## 3 RESPONSES TO COMMENTS ON THE DRAFT EIR

This chapter contains comment letters received during the public review period for the Draft EIR, which concluded on February 19, 2019, including transcribed comments received during the February 14, 2019, public hearing. In conformance with Section 15088(a) of the State CEQA Guidelines, written responses were prepared addressing comments on environmental issues received from reviewers of the Draft EIR.

**Exhibit 3-4**

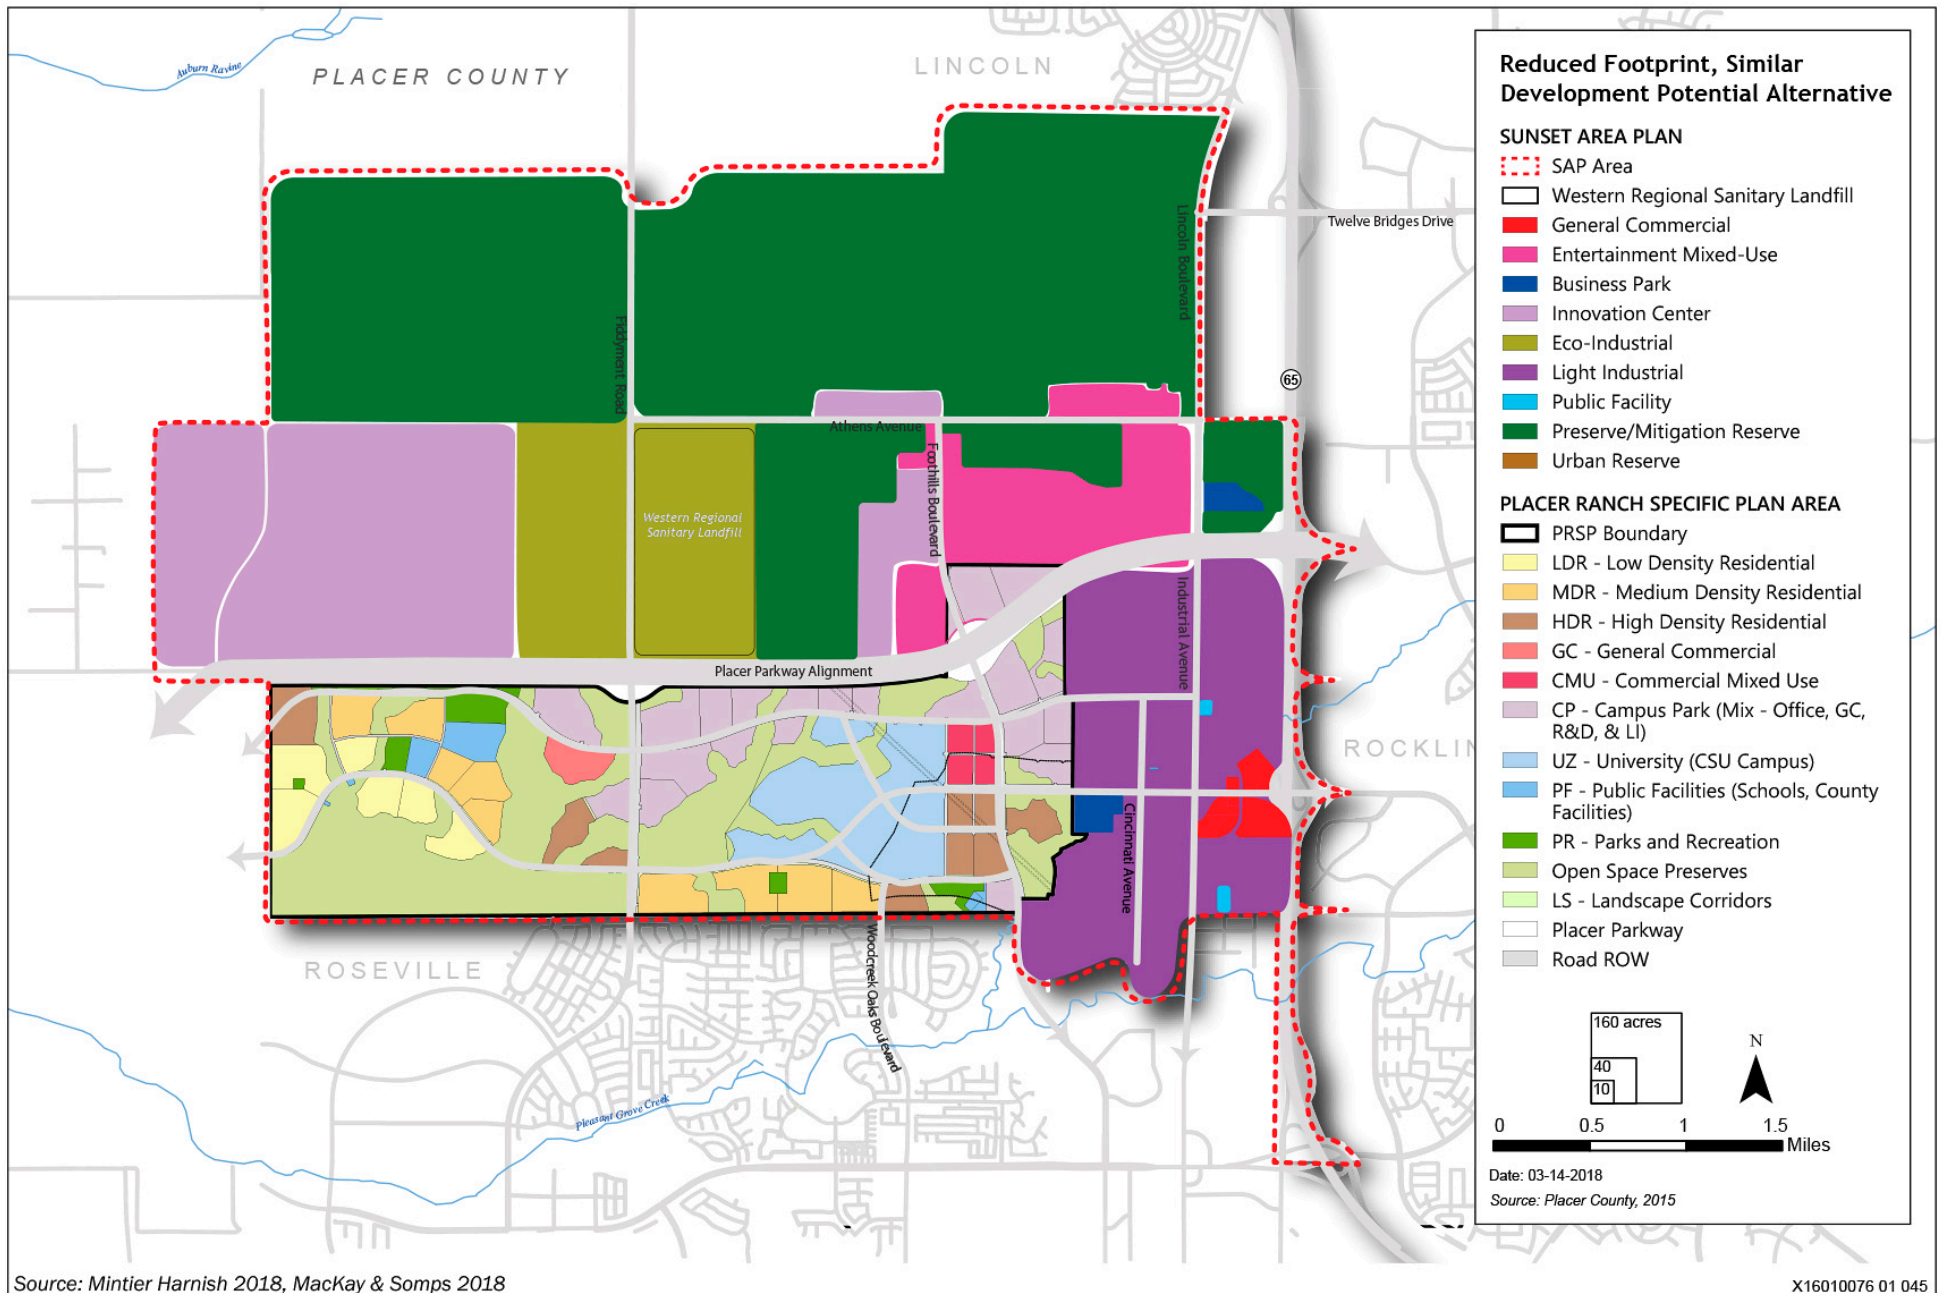
After CCR Section 15204 describes the helpfulness of comments that suggest additional alternatives or mitigation measures that avoid or mitigate significant environmental effects, it indicates that reviewers should, at the same time, be aware that the adequacy of an EIR is determined in terms of what is reasonably feasible, in light of factors such as the magnitude of the project at issue, the severity of its likely environmental impacts, and the geographic scope of the project. The County acknowledges the substantial effort and thought put into the CISGP. County staff examined the various aspects of the CISGP that targeted significant impacts to determine if there were elements that could be incorporated into the project or one of the alternatives. However, as described above, the feasibility issues, especially the issues with the university site and the sheer magnitude and intensity of urban development, as well as the inability to meet primary project objectives, cause the CISGP, and even the separate elements of the CISGP, to fail as a viable alternative to the proposed project. In addition, as discussed above, the CISGP would actually result in greater impacts associated with several of the significant impacts the plan seeks to reduce, most notably traffic and GHG emissions. Finally, the Draft EIR includes Alternative 4, which aims to reduce environmental impacts associated with ground disturbance, especially biological resources, in a similar fashion as the CISGP, but, unlike the CISGP, would not generate significantly greater levels of GHG emissions. The County considers Alternative 4 to be a more reasonable and effective alternative to the project. Therefore, the County is not revising the Draft EIR to include the CISGP as an alternative to the project.

Unlike the CISGP, Alternative 4 includes a potentially viable university site, located within the PRSP area (and therefore potentially still able to be donated) on land that is currently undeveloped (and therefore not constrained by existing structures and property ownership issues). Alternative 4 would therefore not conflict with primary objectives related to the Sac State–Placer Center.

**Exhibit 3-5**

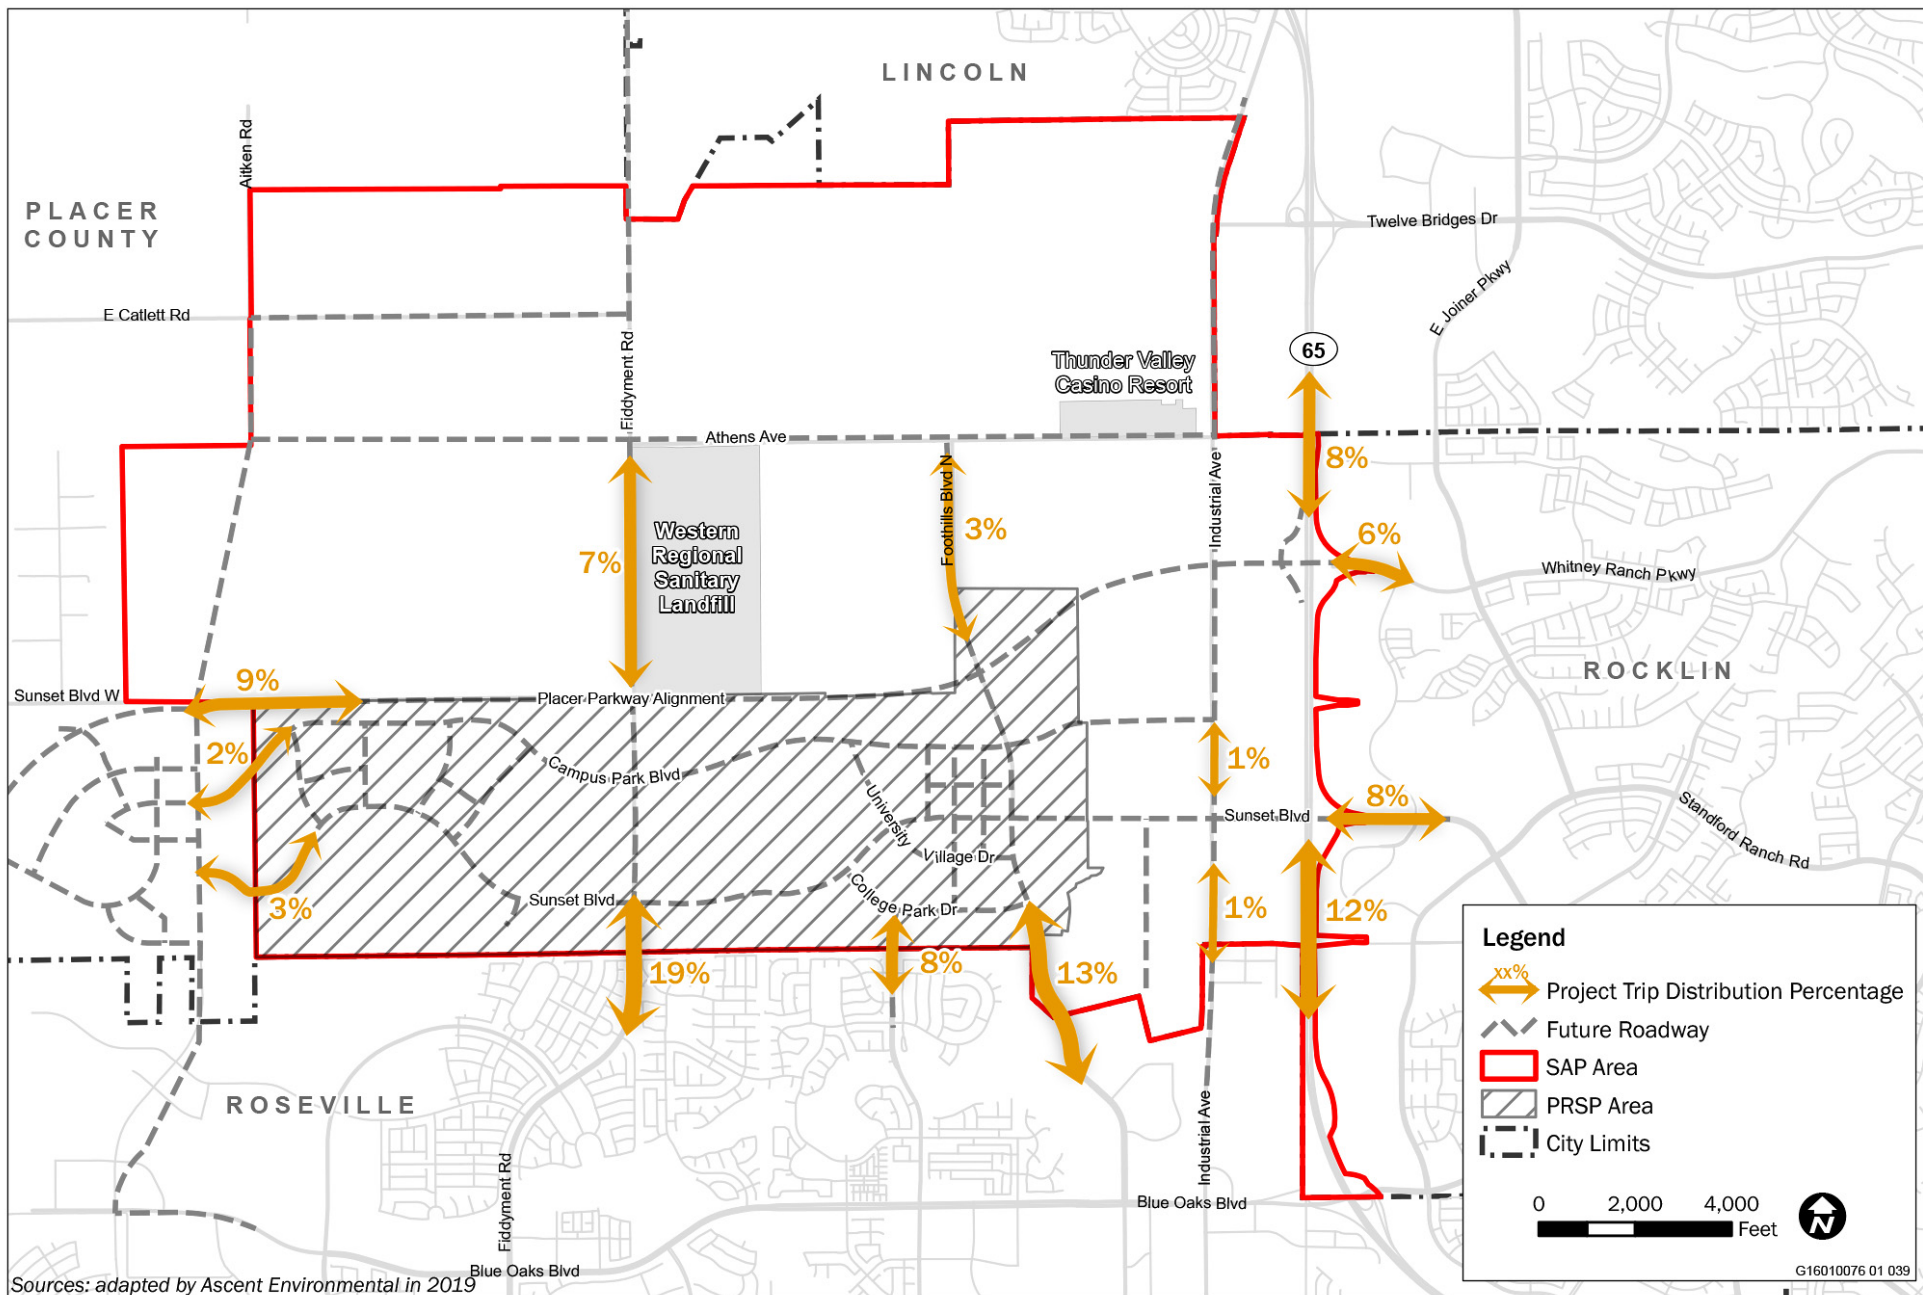
- 1-1 The comment requests a project-only trip generation table to identify the number of trips generated by the project. The comment raises issues with Draft EIR Exhibit 4.14-11, stating that the changes in average daily traffic (ADT) shown do not convey the effects of project trips on State Route 65 (SR 65). The comment also requests a trip distribution figure to show the travel patterns from trips generated by the project. Table 4.14-19 in the Draft EIR presents the project trip generation for the PRSP. As described on page 4.14-43 of the Draft EIR, Exhibit 4.14-11 reflects the project's effect on sub-regional travel patterns. This means the analysis accounts for a redistribution of existing trips that would occur with the proposed project. For example, nearby residents that currently travel to businesses and services further away may instead travel to businesses and services that are located in the PRSP area. As a result, some existing trips on SR 65 travel to destinations in the proposed project, resulting in a decrease in trips on some segments as existing traffic diverts off SR 65. Furthermore, the addition of project trips is partially offset by this redistribution of existing trips resulting in a lower net increase. As shown in this figure, the greatest change in traffic occurs on roadways that directly serve the PRSP area, which is expected with the addition of project uses. Intuitively, the project's effect on traffic dissipates further from the project.

In response to the comment, a trip distribution exhibit has been prepared (Exhibit 3-5).
